NGDV – Technical Bulletin

Title: Seat Belt Buckle Wire Harness Routing	
Number: NGDVTB014	Revision: -
Classification: Highly Restricted

NGDVTB014 – SEAT BELT BUCKLE WIRE ROUTING

Figure 1

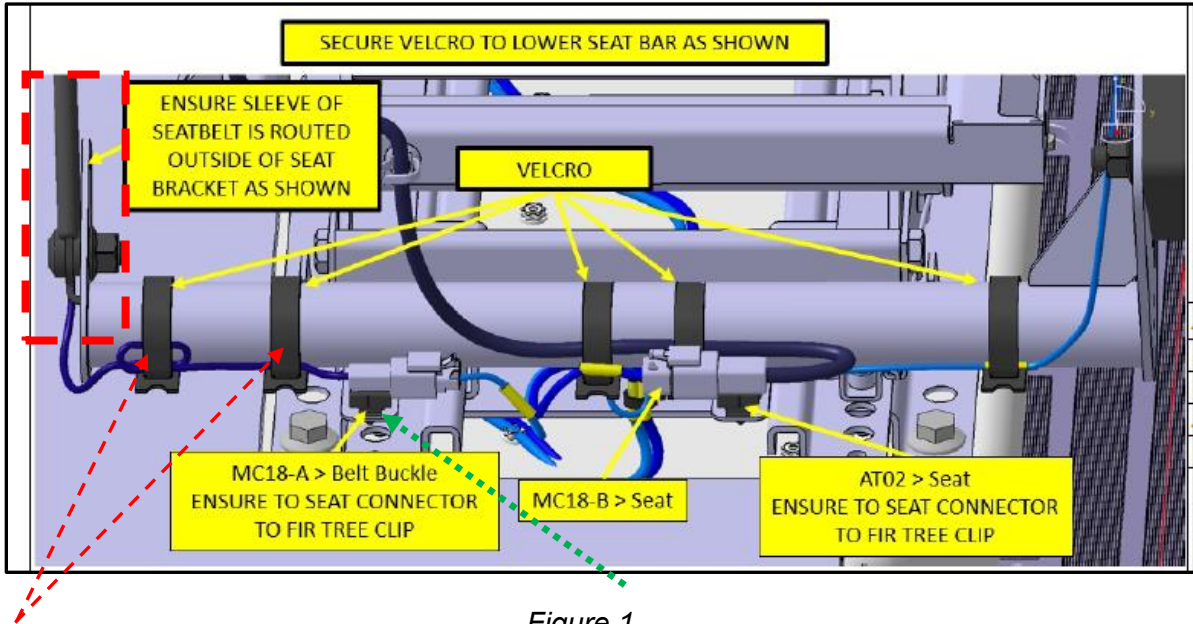
- a. Remove the T50 Torx bolt securing the seat belt to the seat by using an T50 torq bit and an 17mm wrench to secure the nut on the back side represented by the red-dashed rectangle in *Figure 1*. Discard the hardware as it is NOT re-usable.
- b. Disconnect the MC-18-A connector at the back of the seat as shown in *Figure 1*. Press down on the locking tab of the connector and pull the female portion of the connector towards the roadside of the vehicle.

6. Undo the 2 velcro straps that secure the wire harness to the seat frame. Only remove the 2 left Velcro straps noted by the red-dashed arrows as illustrated in *Figure 1*. Save the Velcro straps as they will be used in the reassembly of the new buckle/harness.
7. Disconnect old buckle/harness pigtail from the connector clip at MC18-A with a flat head screwdriver. This fir tree is noted in *Figure 1* with the green-dotted arrow.
 - a. The removed buckle/harness can be discarded and does not need to be sent back to Oshkosh.
8. Install the new Seat Belt Buckle by placing the bolt through the seat frame and hand tighten the nut on the back side as shown in *Figure 1* again using the 17mm wrench and the T50 6-lobed Torx bit.
 - a. Torque the bolt to 60 ft-lbs
9. Route the harness of the Seat Belt Buckle as shown in *Figure 2* with the wire harness on the bottom or beneath the bolt.

Figure 4

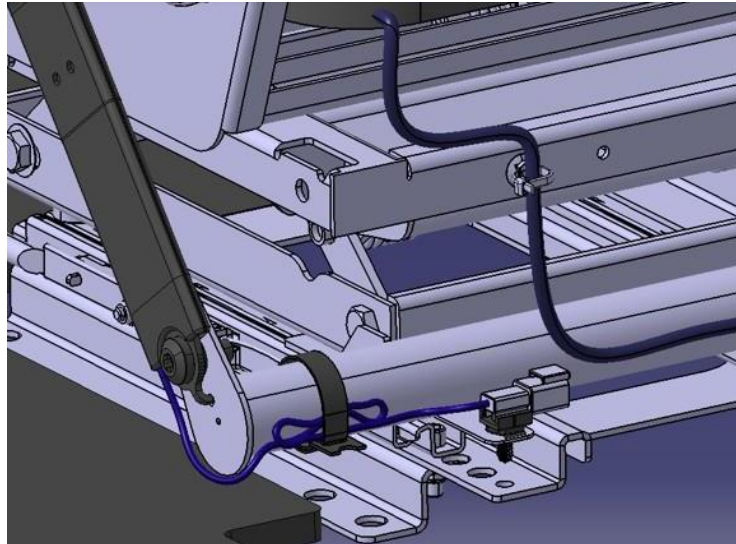
11. Route the remainder of the harness as shown in Figure 4 where the harness is secured to the bottom of the seat frame tube and has an approximate 3.0” to 5.0” loop in the harness secured by the first Velcro Strap as noted by the red-dashed line.

Figure 5

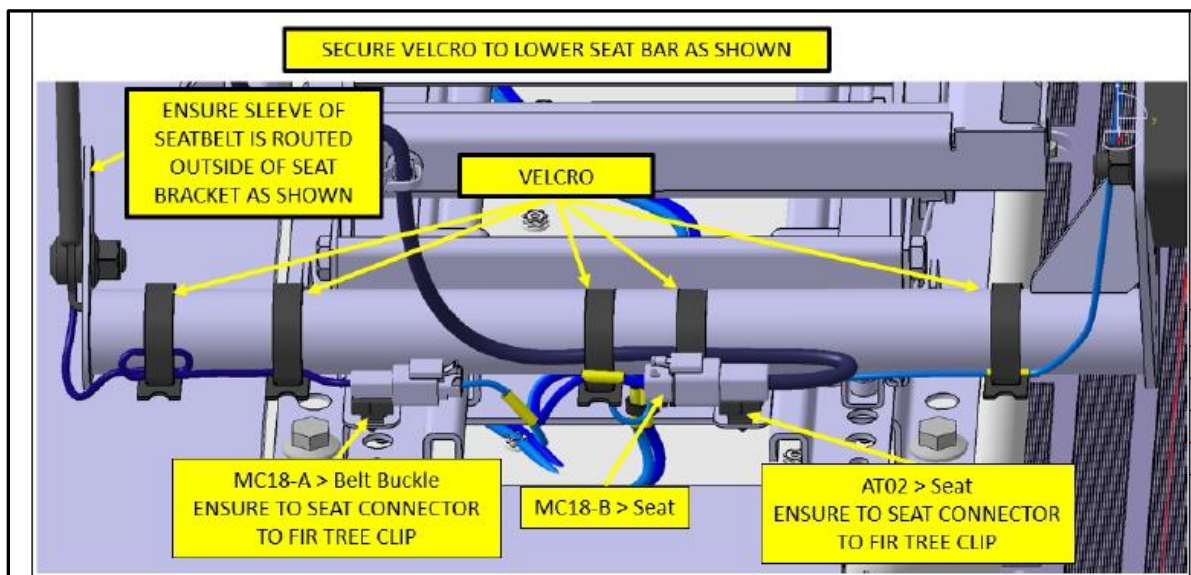
12. Secure the remainder of the harness in the next Velcro loop and plug in the MC18-A connector by pushing the female portion of the connector into the male portion of the connector until it is locked or a “click” is heard.
